Response to U.S. EPR Design Certification Application RAI No. 389, Supplement 10

Request for Additional Information No. 389(4615), Revision 1, Supplement 10

SRP Section: 06.02.02 - Containment Heat Removal Systems

Figure 06.02.02-47-1—Modeling Sketch for Suction Break

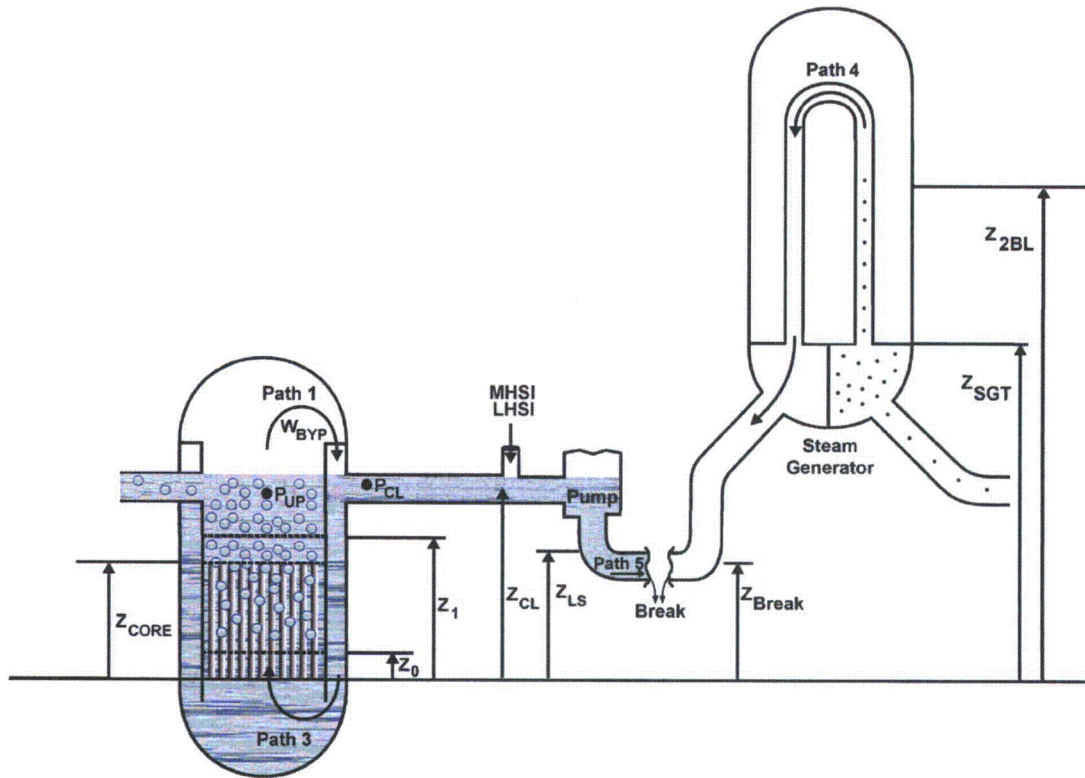
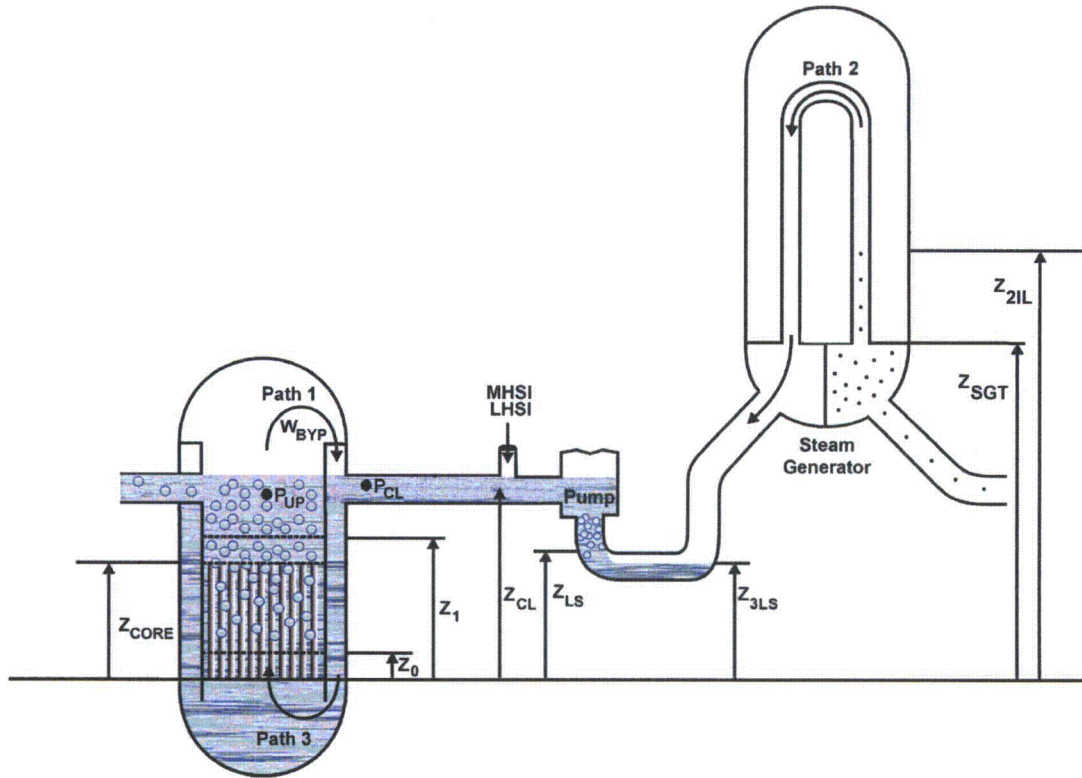
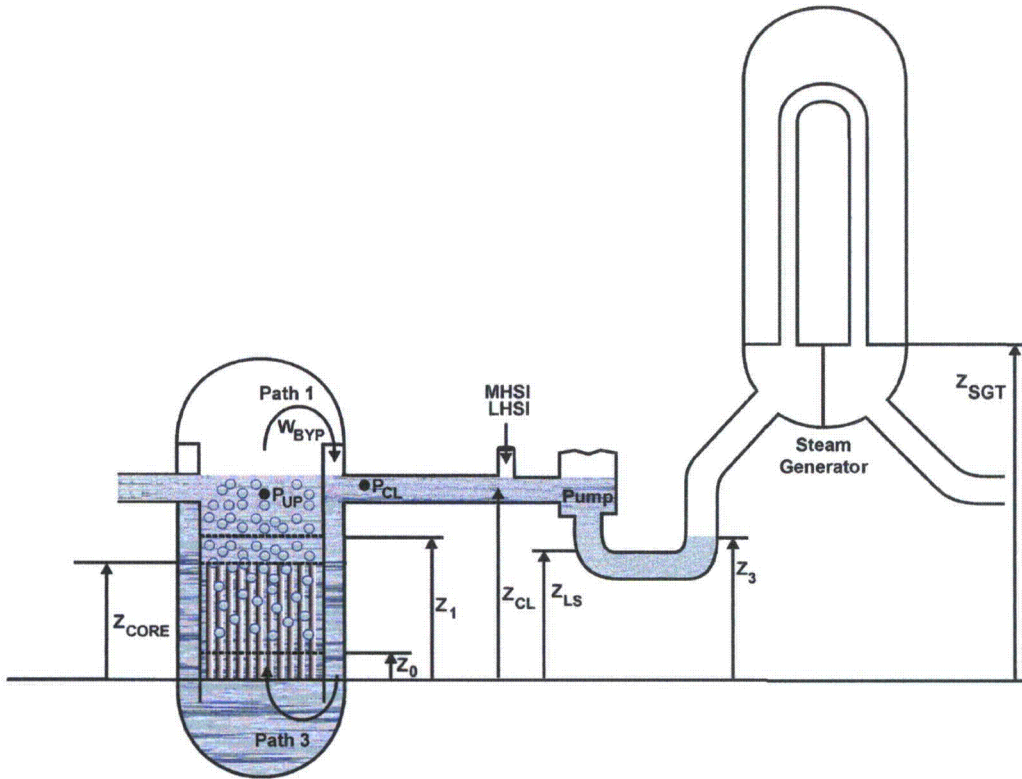
The staff therefore requests that AREVA calculate the M&E source for cold leg breaks using phenomenological considerations for two phase level swell in the core and to assume that all steam and water carried out of the reactor vessel travels out of the broken loop after the time when the loop seals in the intact cold legs are blocked. With the revised M&E source, calculate the containment pressure for cold leg breaks using AREVA's multi-noded GOTHIC containment model.

Figures 06.02.02-47-1 through 06.02.02-47-3 illustrate the modeling for the approach of this assessment, which is based on static balance concepts applied to the reactor system. Figures

06.02.02-47-1 through 06.02.02-47-3 show direct steam discharge from the broken loop SG to the break. The vented intact loops flow to the downcomer, where they combine and flow to the break. The vented intact loop steam flow to containment is reduced by condensation from subcooled water from the safety injection (SI). Non-vented (blocked) loop seals do not allow steam flow.

2. Figure 06.02.02-47-1 through Figure 06.02.02-47-3 show modeling concepts specific to the cold leg suction break:

- 
3. The broken loop is always vented for a suction break, while the intact loops can either be vented or non-vented. A loop seal fills by countercurrent backflow of subcooled water from SI in the discharge piping through the pump. A loop seal of an intact loop, without SI, could also fill by countercurrent backflow from a sufficient head of water in the downcomer. Based on countercurrent flow limiting (CCFL) considerations, a loop seal is flooded with the availability of SI water as decay heat steaming is reduced during post-reflood. The steam in a vented intact loop flows from the upper plenum to its respective cold leg. A non-vented intact loop has no steam flow because the loop seal has filled with water and blocks the steam flow.

4. Vented and non-vented intact loops can coexist because there are two pressure drop solutions. Figure 06.02.02-47-2 shows Z_1 above the loop seal and in balance with the loop seal water level Z_{3LS} and other aspects of pressure drop for a vented loop. Figure 06.02.02-47-3 shows the same Z_1 in a non-vented loop (zero steam flow), where Z_1 is in simple hydrostatic balance with water level Z_3 that is above the loop seal on the SG side. Depression of Z_3 below the top of the loop seal allows vapor to enter the loop seal. Vapor entry into the vertical section under the pump reduces the liquid hydrostatic head. The resulting pressure imbalance drains the loop seal like a "plumbing trap" and allows loop venting. []
While a higher or lower value could be selected, this value was chosen because water depression to that level is the start of significant vapor flow in a loop seal. See the Response to RAI 403, Question 15.06.05-73 for more information.

Figure 7.3-14—MSIV Isolation (Div. 1&2)

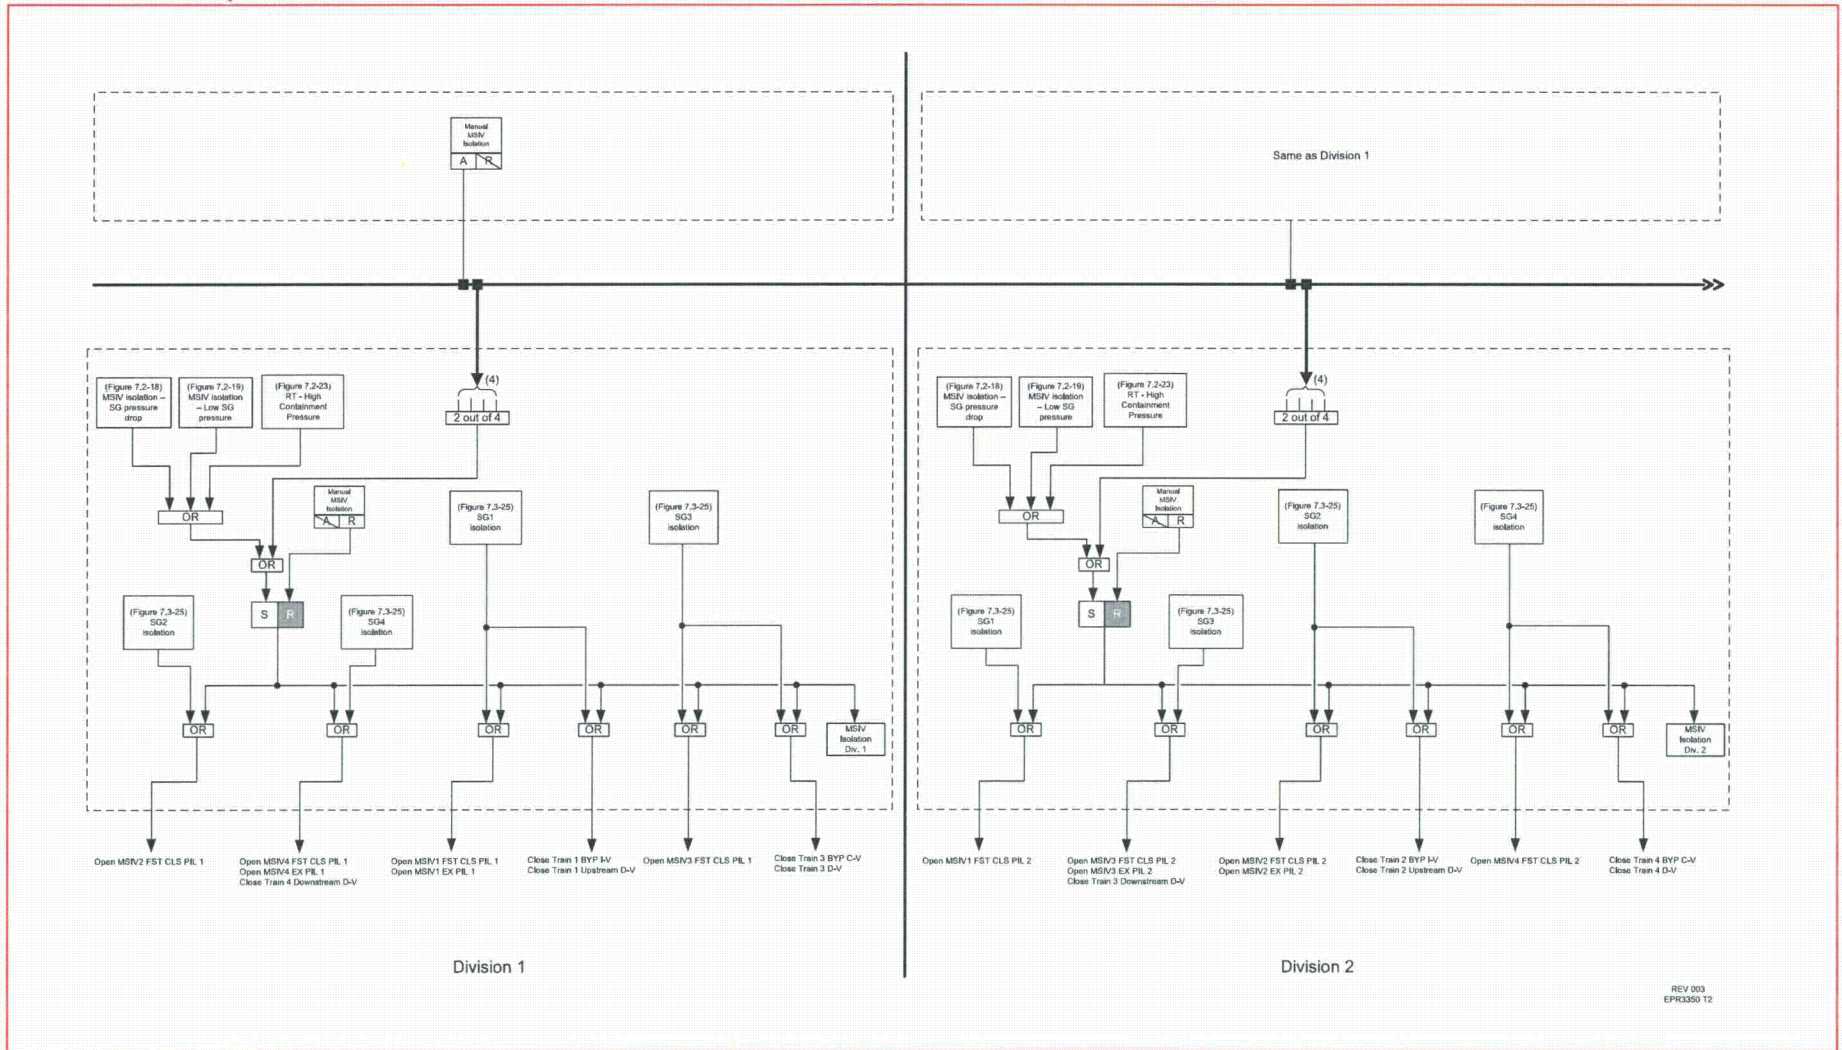
Interim FSAR Revision 2 Table 6.2.1-25, "MSLB Reactor Trip and Isolation Signal Summary" includes steam generator isolation on high containment pressure to mitigate small steam line breaks. Include this signal in the steam generator isolation discussions of FSAR Chapter 7.3 "Engineered Safety Features Systems".

U.S. EPR FSAR Tier 2, Table 6.2.1-25, "MSLB Reactor Trip and Isolation Signal Summary" includes main steam isolation and main feedwater (MFW) isolation on high containment pressure, but not a steam generator (SG) isolation signal. Containment isolation and a reactor trip (RT) also occur on a high containment pressure signal (Containment Equipment Compartment Pressure > Max1p and Containment Service Compartment Pressure (NR) > Max2p). U.S. EPR FSAR Tier 2, Section 7.3.1.2.7 and Section 7.3.1.2.8 will be revised to include main steam isolation and MFW isolation on high containment pressure, respectively. Associated changes will be made to U.S. EPR FSAR Tier 2, Table 7.3-1, Figure 7.3-14, Figure 7.3-15 and Figure 7.3-17. U.S. EPR FSAR Tier 1 Table 2.4.1-3 will be revised to include additional main steam isolation signal input variables.

The functional logic for automatic main steam isolation is shown in Figure 7.3-14—MSIV Isolation (Div. 1&2) and Figure 7.3-15—MSIV Isolation (Div. 3&4).
